# knitter-switch

## Product Change Notice

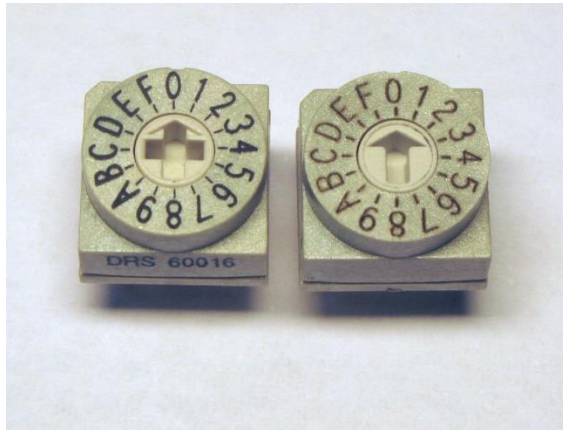
To prevent increase of delivery delay, switch position display and part number marking is changed from pad print to laser marking. This change is not affecting any other features or specification of the components.

Left hand side: pad print  
Right hand side: laser marking  
(rotor style for reference only)
